3482  
SL-062648  
UTU-68082  
(UT-066)

Re: Modification Request for Resource Recovery and Protection Plan (R2P2), 50-foot Property Barrier and Northwest Mining Block, Crandall Canyon Mine

# ENCLOSURE 2

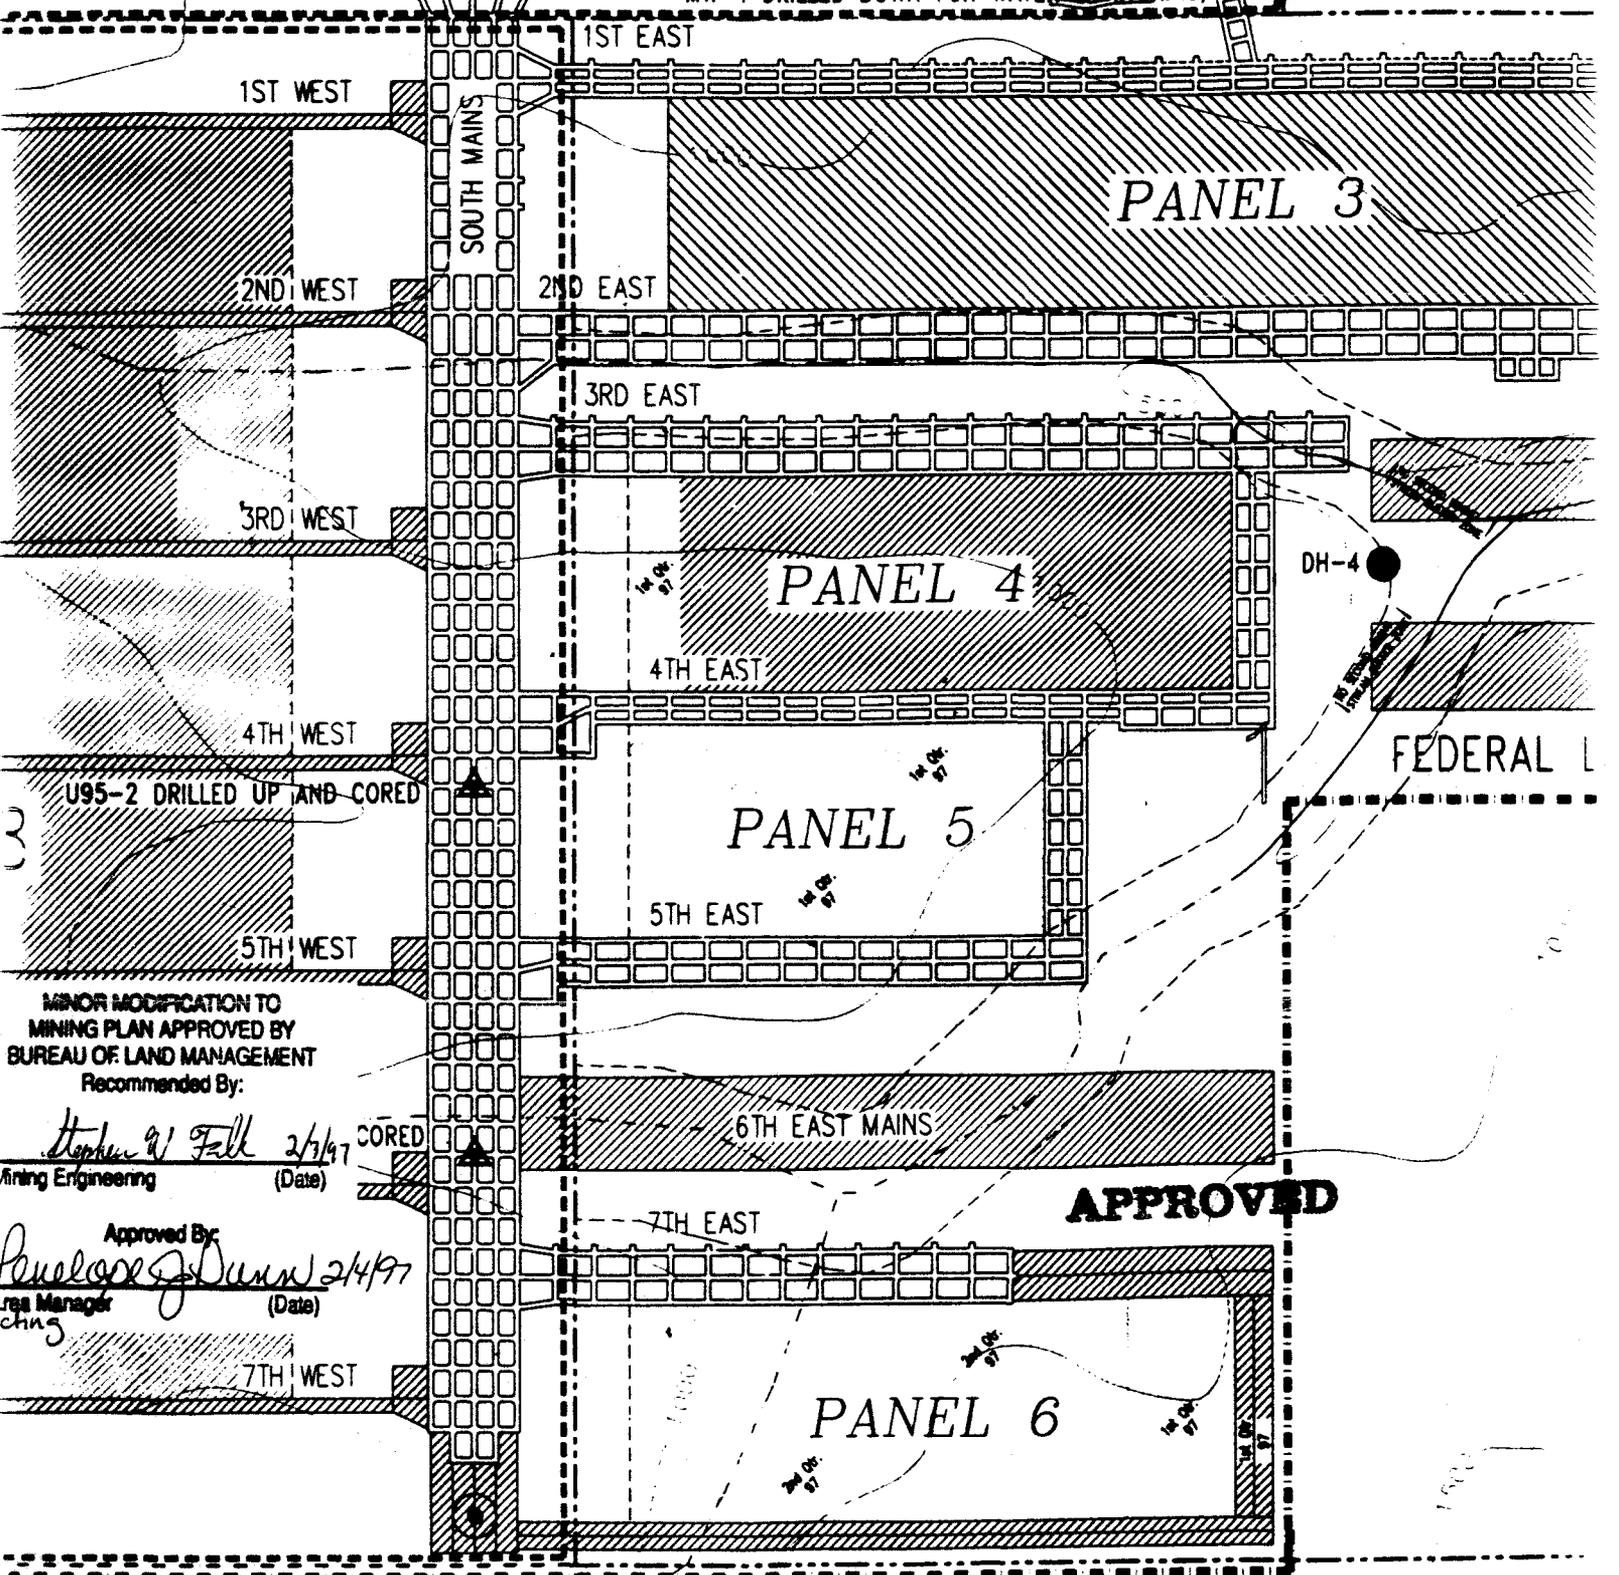
Genwal proposes to increase the size of the north barrier to the planned 6th East Mains off South Mains from 200 to 300 feet. This would shift longwall panel #6 (8th East) south, which would place the 8th East headgate entries at or beyond the 50-foot property barrier boundary. In addition, Genwal has planned a number of changes for the northwest coal block (section 35) that BLM will address at the end of this letter.

The request for the barrier increase and the shifting of the mining projections south is a logical adjustment to the mine layout. The 6th East Mains would have equal barriers on both sides of the entries and should adequately protect the main entries from the adjacent longwall panels. In addition, the 6th East Mains will be better positioned under Crandall Creek. By so shifting the layout, mine entries will be inside the 50-foot property barrier as specified in 43 CFR 3484.1(c)(6). However, in this case, the BLM agrees that the property barrier pillar is not needed, as the land adjacent to this lease is unleased Federal coal which Genwal has applied for lease. No other interests in the land have been expressed. Should another party other than Genwal obtain the lease, however unlikely, an agreement can be worked out as to the barrier left between adjacent mine workings.

Further changes to the R2P2 were depicted in submitted plate 5-2 for the northwest longwall block. To address these changes properly, some explanation is required. Genwal was authorized by this office in a previous R2P2 modification (dated 5/29/96) to mine the 2nd North entries parallel to the old 1st Right north to the limits of the minable coal. BLM witnessed the

To approve all of the changes for the area, BLM will need further information for justification, such as the reasons for the barrier pillar sizing and bleeder entry configuration. Though we agree with the fundamentals of the changes that you have discussed with us, we will need this information in writing as required by the regulations at 43 CFR 3482.2 (c) (2). We have enclosed for your information a copy of an instructional letter that was sent some years ago to all coal operators to clarify requirements in making changes to the approved R2P2. Our purpose for this information request is not punitive or to slow the approval process, but to assure that the official lease record has proper justification to protect all parties involved. Genwal's October 18 submittal contained no justifications. However, we will still approve the 6th East Mains/50-foot property barrier modifications, as the justification for the changes were obvious and were discussed verbally with BLM representatives.

The BLM has determined that the modifications in the proposed 6th East Mains and longwall panel #6 meet the requirements of the Mineral Leasing Act of 1920, as amended, the regulations at 43 CFR 3480, the lease terms and conditions, and will achieve maximum economic recovery of the Federal coal. This confirms verbal approval given previously. A copy of the approved mine map is enclosed. Genwal is still authorized to develop the 6th West off 2nd North gate entries to the limits of the minable coal seam. Further justification is necessary for approval for the rest of the northwest longwall block as was explained above. If you have any questions, please contact Stephen Falk of my staff at 636-3600.

MINOR MODIFICATION TO MINING PLAN APPROVED BY BUREAU OF LAND MANAGEMENT Recommended By:

**APPROVED**
